HERON LANDING SUBDIVISION

APPLICATION NUMBER Holdover DATE July 20, 2006
APPLICANT Heron Landing Subdivision
REQUEST Subdivision

DETAIL SITE PLAN

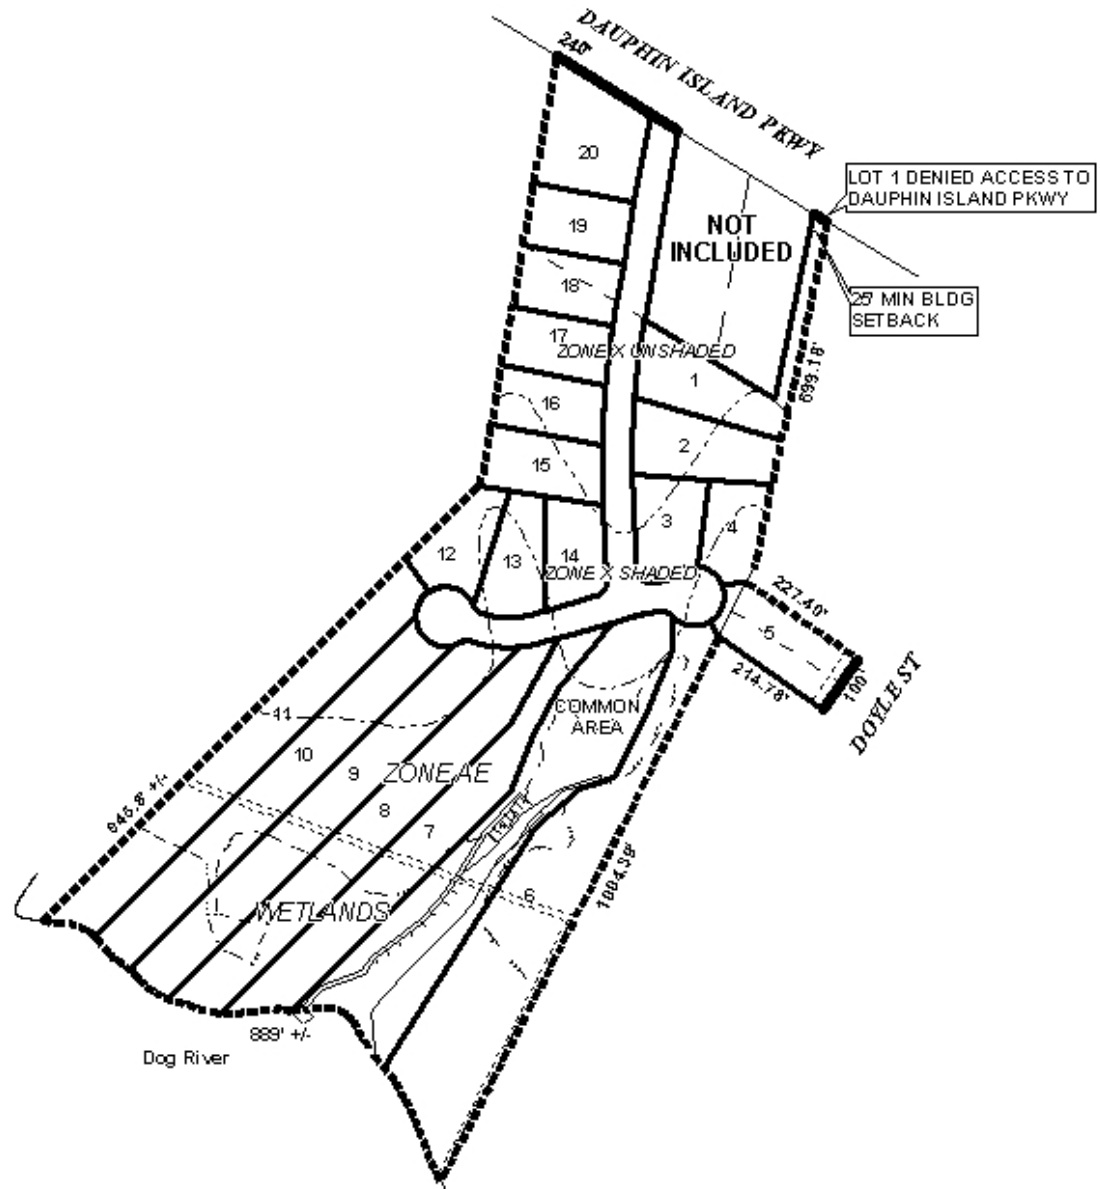
The site fronts on Dauphin Island Parkway, a major street with adequate right-of-way, and has a portion of the site abutting Doyle Street, a minor street lacking curb and gutter. The existing right-of-way for Doyle Street where the site abuts it is 50-feet, which is not adequate due to the street lacking curb and gutter. Since Doyle Street dead-ends at Dog River, and due to the limited number of homes served by the street, it is recommended that the minimum building setback from Doyle Street for the site in question be increased to provide 55 feet, as measured from the centerline of Doyle Street. Access to Doyle Street from Lot 5 should be denied.

The proposed Lot 1 has frontage on both the proposed residential street and Dauphin Island Parkway. The frontage on Dauphin Island Parkway is only 25-feet, and no justification is provided for the 25 by 320 foot long strip to be part of the proposed Lot 1. It is recommended, therefore, that the subdivision application be revised to include the remainder of Schulz Commercial Subdivision (two lots of which are already included as part of the application) so

The 25-foot minimum building setback line from the right-of-way edge is not depicted for all proposed lots, and will be required (from the right-of-way setback) on the final plat.

Proposed Lots 6 – 11 do not comply with the recommended depth to width ratio in Section V.D.3. of the Subdivision Regulations. Due to the proximity to Dog River and the potential presence of wetlands, a waiver of Section V.D.3. may be appropriate.

It should also be noted that the final plats for the subdivisions approved in 2002 depicted drainage easements and sanitary sewer easements that are not depicted on the current application's preliminary plat. The plat should be revised to show all easements that occur on the site, as they may affect the applicant's ability to develop the site.

Based upon the preceding, this application is recommend for Holdover until the August 3rd meeting to allow the applicant to revise the plat and application by July 10th to include: 1) depiction of any drainage and sanitary sewer easements; 2) depiction of FEMA flood zone and required finished floor elevation information; 3) revision of the Subdivision application to

include the remainder of the Schulz Commercial Subdivision so that the strip of land associated with the proposed Lot 1 can instead be made part of the commercial lots fronting Dauphin Island Parkway; and 4) application for rezoning to remove any split-zoning condition for proposed Lot 18, to convert proposed Lot 19 to a residential zoning district, and to convert the strip of Lot 1 to a commercial zoning designation, if the strip is combined with the commercial lots fronting Dauphin Island Parkway.

With a waiver of Section V.D.3. of the Subdivision Regulations, this application is recommended for Tentative Approval, subject to the following conditions: 1) depiction and labeling of all drainage and sanitary sewer easements on the final plat; 2) depiction and labeling of FEMA flood zones and required finished floor elevation information on the final plat; 3) revision of the plat to include the phrase "future development" across all lots not proposed for inclusion in first phase of the subdivision; 4) placement of a note on the final plat stating that proposed lots 18-20 shall not be recorded until the zoning issues for lots 18 and 19 are resolved; 5) placement of a note on the plat stating that lot 5 is denied access to Doyle Street, and that lot 1 is denied direct access to Dauphin Island Parkway; 6) placement of a note on the plat stating that lot 20 is denied direct access to the proposed street, if it remains commercially zoned, and that the number, size and location of any curb-cuts onto Dauphin Island Parkway must be approved by Traffic Engineering and ALDOT, and conform to AASHTO standards, however, if lot 20 is rezoned to a residential designation, it shall be denied access to Dauphin Island Parkway; 7) revision of the plat to depict a 55-foot setback line, as measured from the centerline of Doyle Street, for lot 5; 8) revision of the plat to depict the 25-foot minimum building setback line from the right-of-way for all lots; 9) placement of a note on the final plat stating that the design and location of the proposed road intersection with Dauphin Island Parkway be approved by Traffic Engineering and ALDOT, and conform to AASHTO standards; 10) placement of a note on the final plat stating that approval of all applicable federal, state and local agencies is required prior to the issuance of any permits or land disturbance activities; and 11) full compliance with all other municipal codes and ordinances.
